Transport Topic Paper

Symmetry Park, Ardley and Land at M40 Junction 10

Tritax Symmetry Ardley Limited and Albion Land Limited

General Arrangement and RSA1 Response Plan

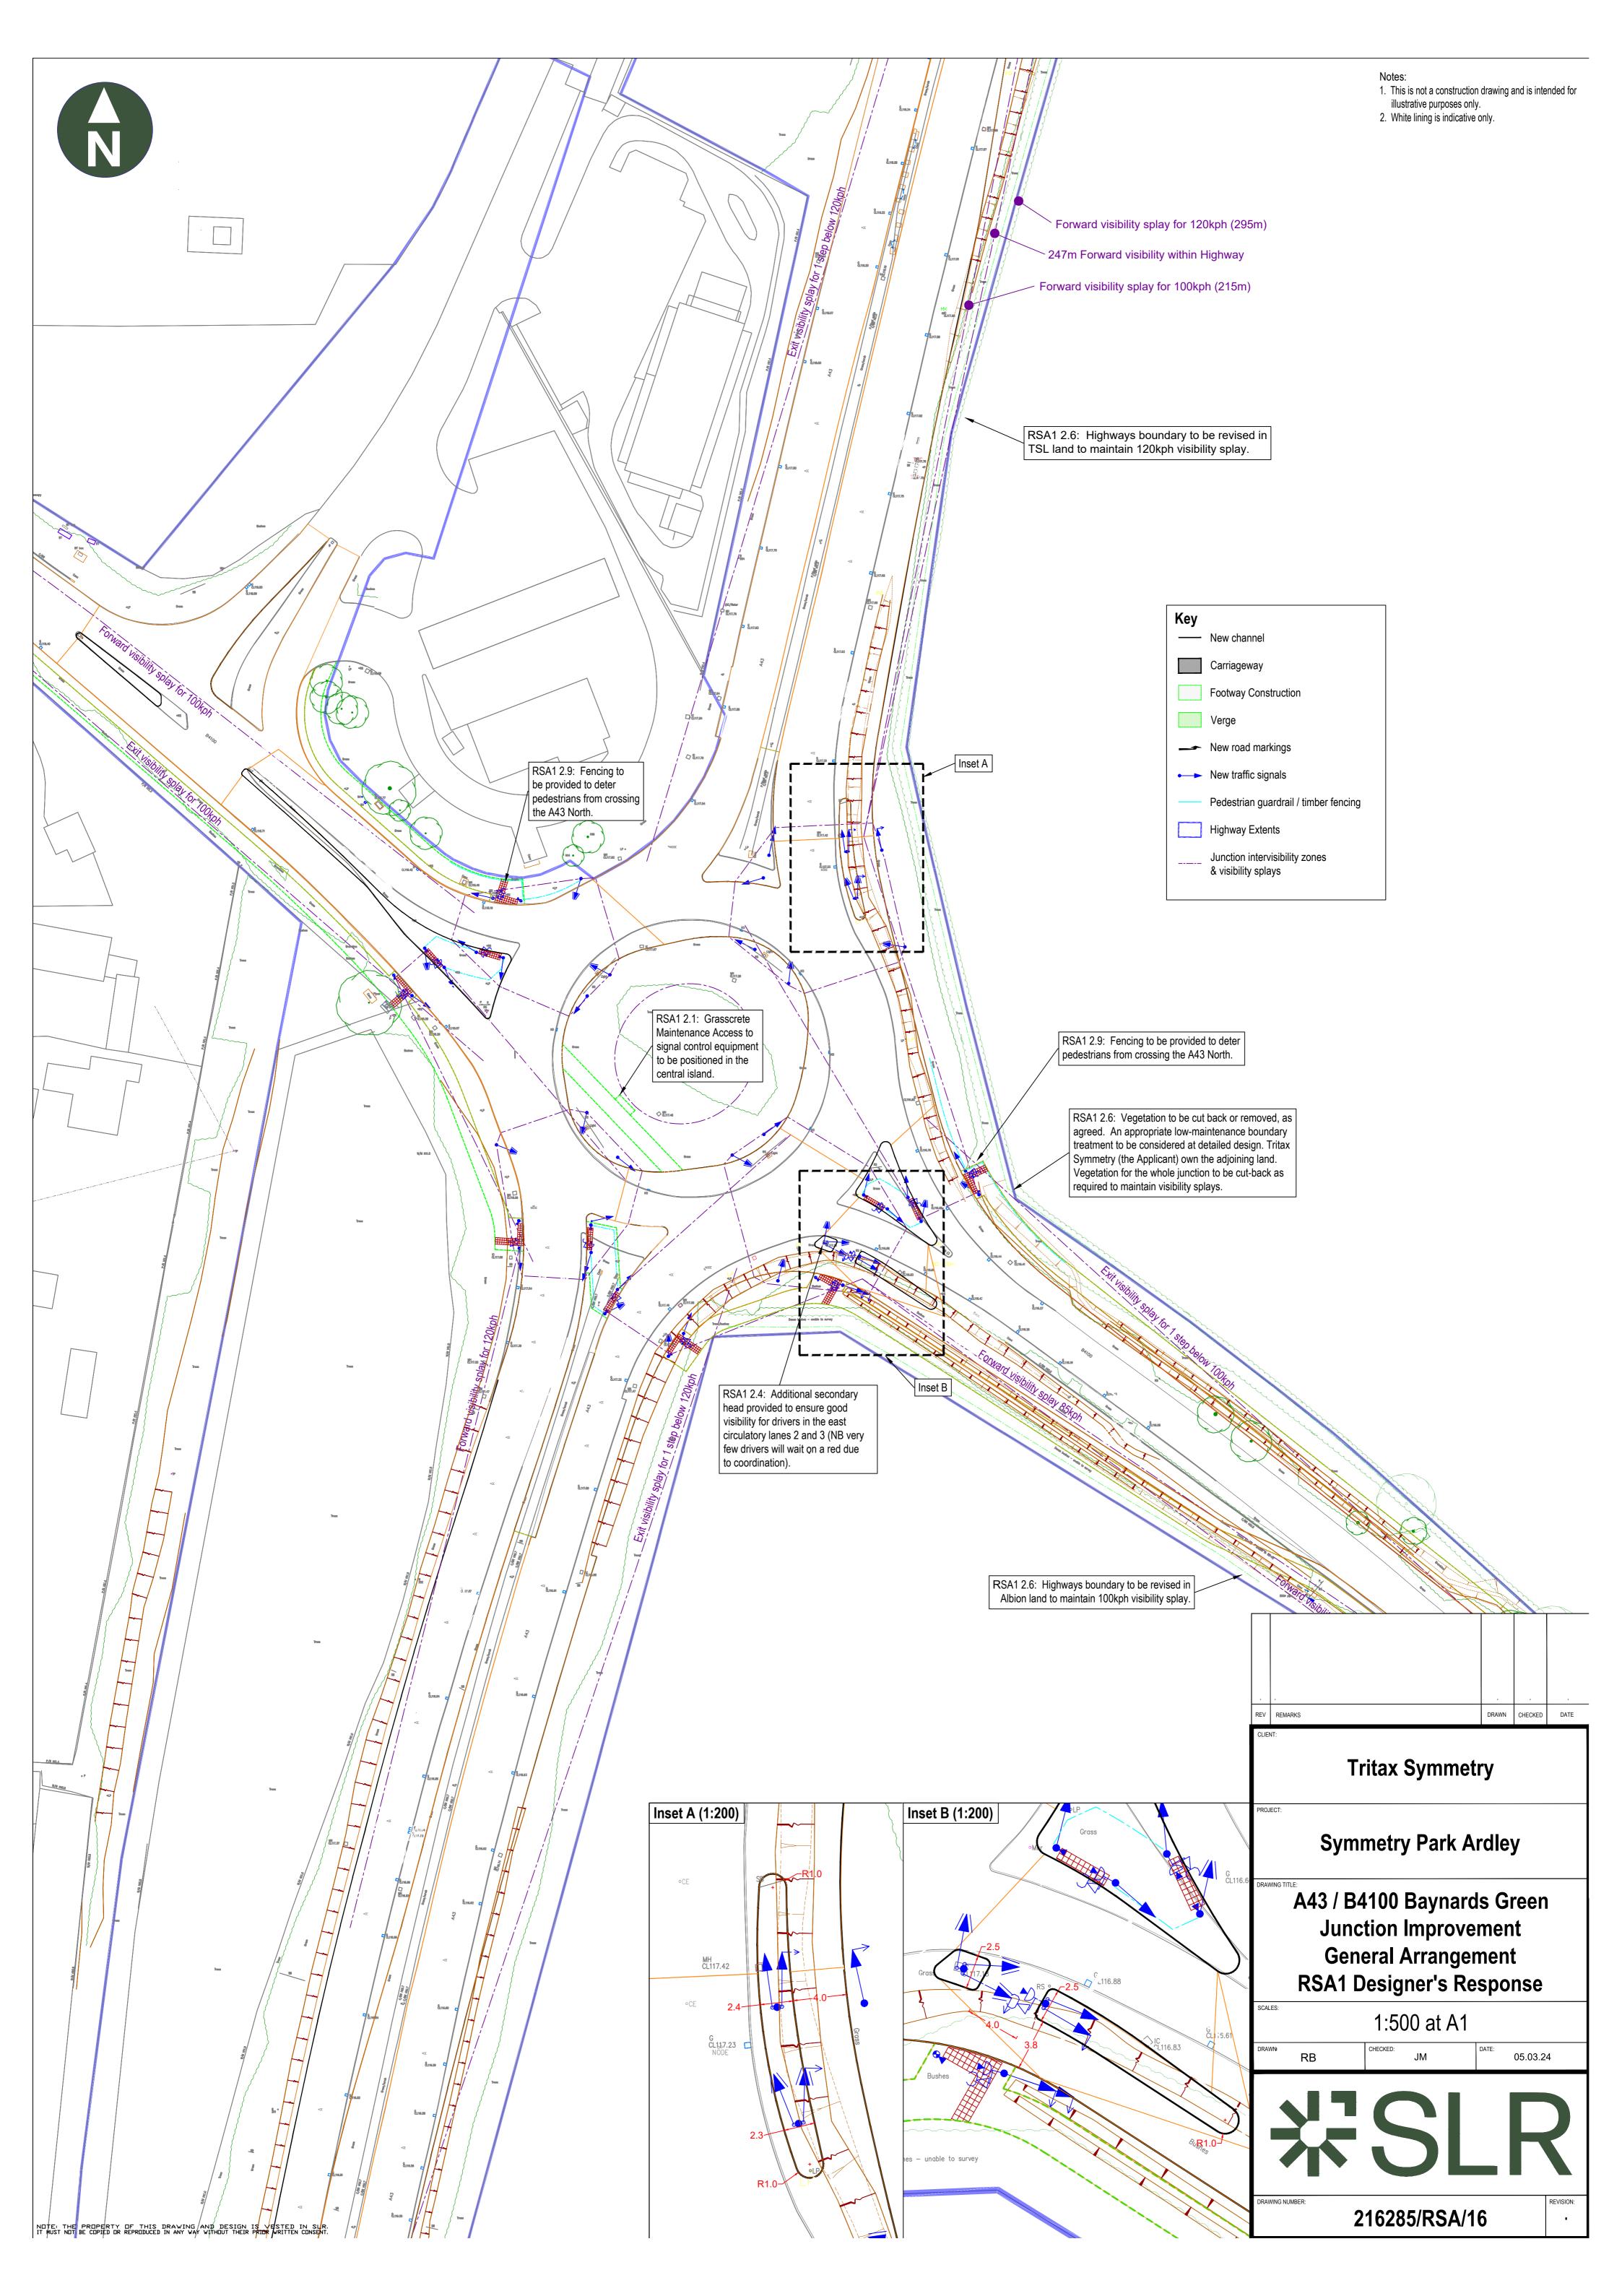
RSA REPORT TITLE LAND ADJACENT TO M40 JUNCTION 10	
Date	February 2024
Document Reference and Revision:	SG/JS/2309-11 RSA1 v1.0
Prepared by:	Steve Giles – Gateway RSE
On behalf of:	National Highways
AUTHORISATION SHEET	
Project:	A43 / B4100 Baynards Green Roundabout
Report Title	Stage 1 Road Safety Audit Designer Response
DESIGNERS RESPONSE PF	REPARED BY
Name:	Richard Bishop
Signed:	
Organisation:	SLR Consulting
Date:	11.03.24

ON BEHALF OF THE OVERSEEING ORGANISATION I CERTIFY THAT: THE RSA ACTIONS IDENTIFIED IN RESPONSE TO THE ROAD SAFETY AUDIT PROBLEMS IN THE ROAD SAFETY AUDIT HAVE BEEN DISCUSSED AND AGREED WITH THE DESIGN ORGANISATION; AND THE AGREED RSA ACTIONS WILL BE PROGRESSED.						
Name	Martin Seldon					
Signed						
Position	Assistant Spatial Planner					
Organisation	National Highways					
Date	12.03.2024
